Office Action Summary

10/624,649

RICCI ET AL.

FIG. 2

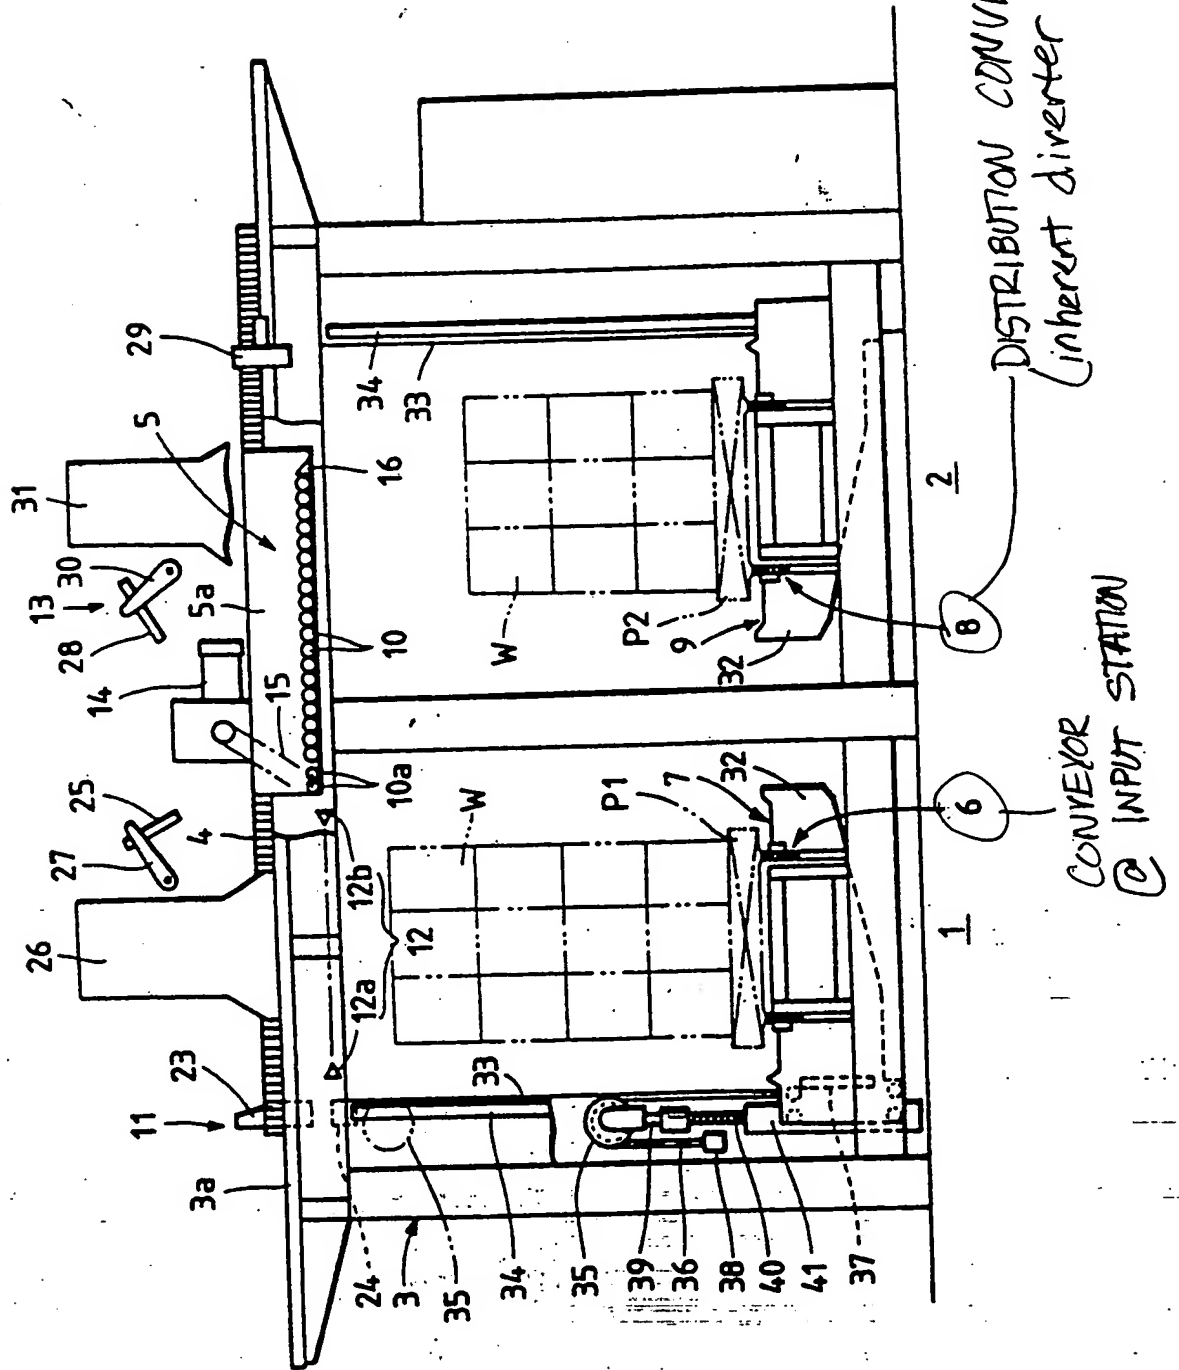
See the attached marked up drawing sheets: 2 of 6, 4 of 6, and 5 of 6 of Hasegawa depicting the claimed features.

FIG. 4a

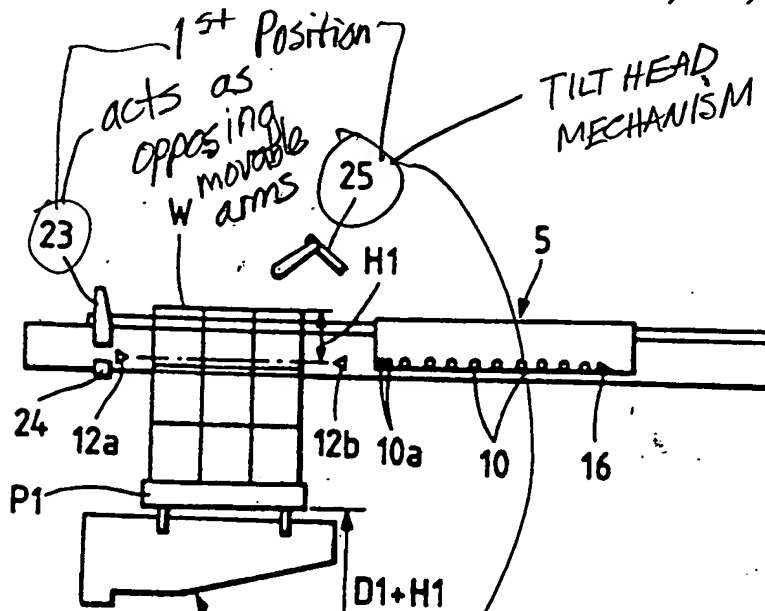
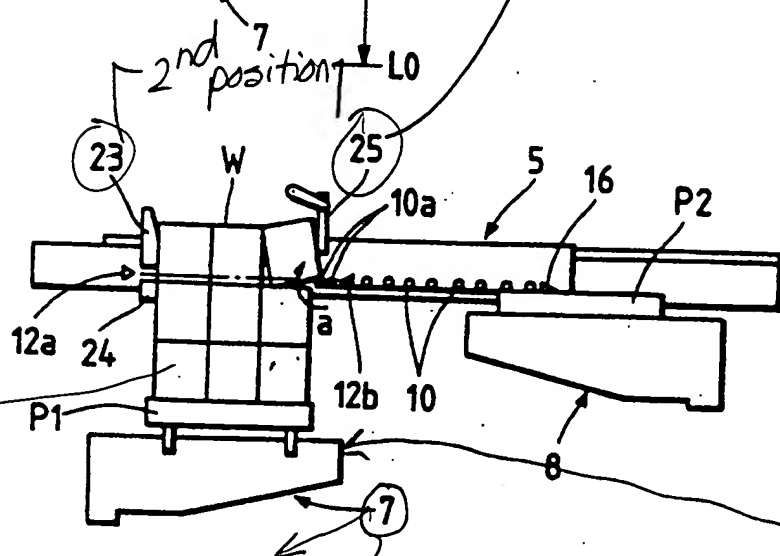
construed as
Mail objects
and flats as claimed

LIFTING DEVICE w PLATFORM

HEAD/HOING DEVICE (opposing movable arms)

FIG. 5

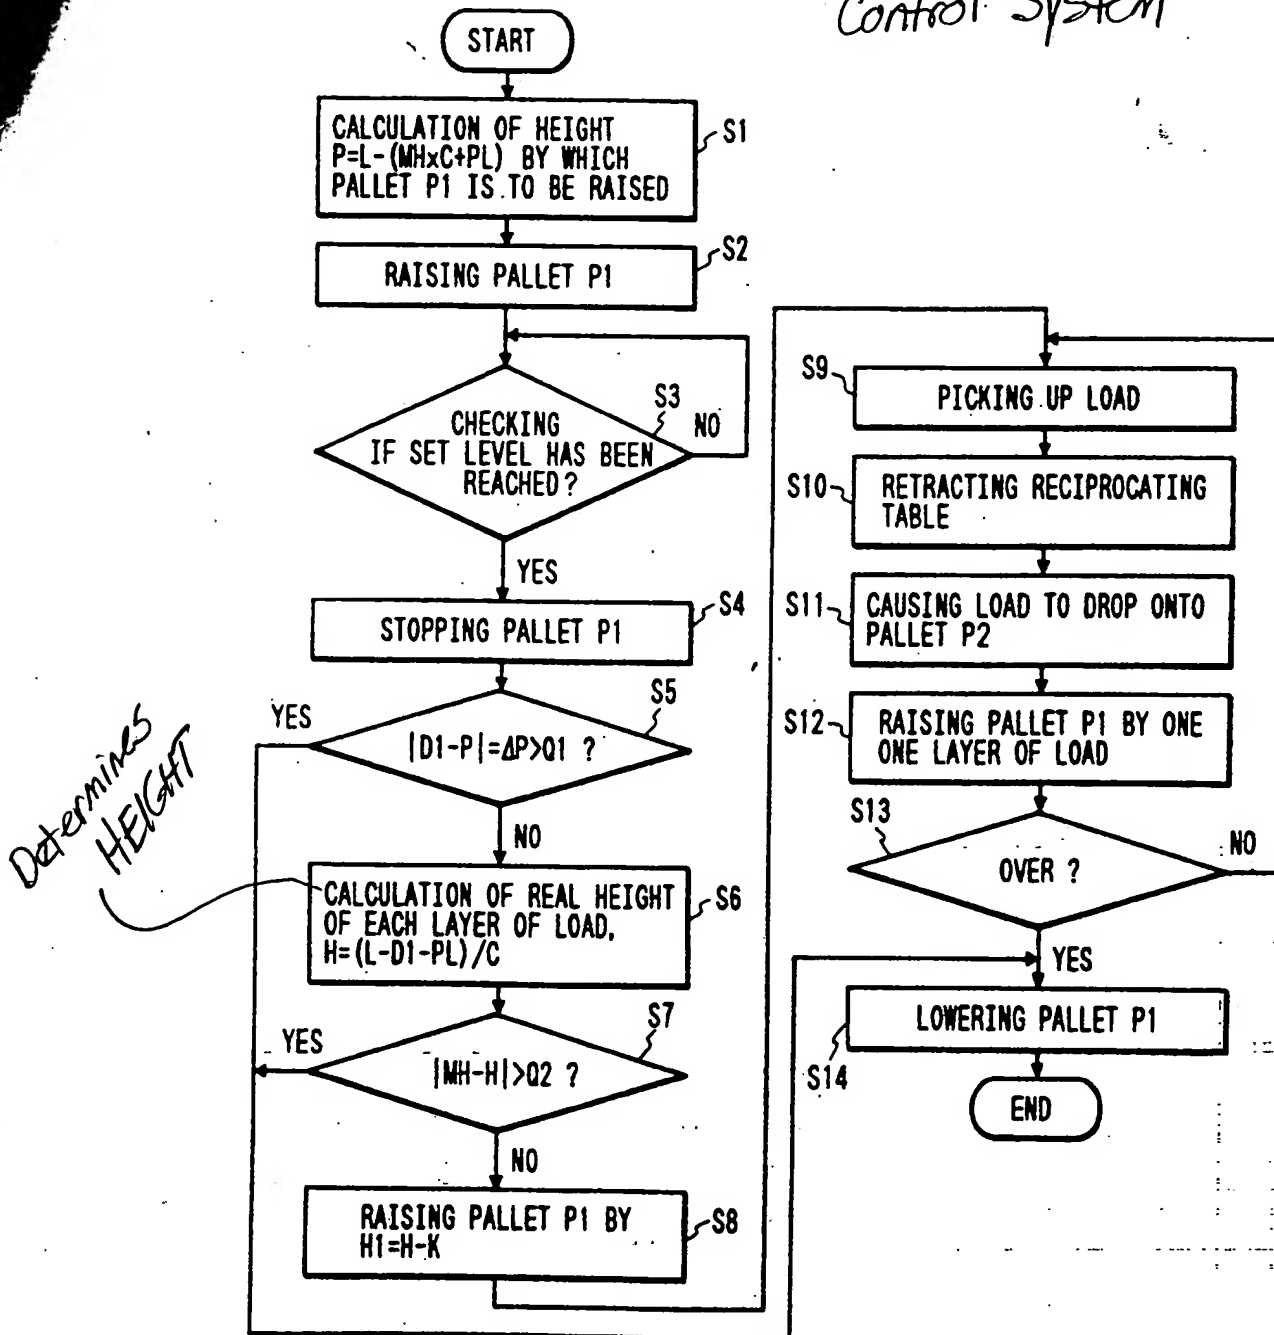
Control System
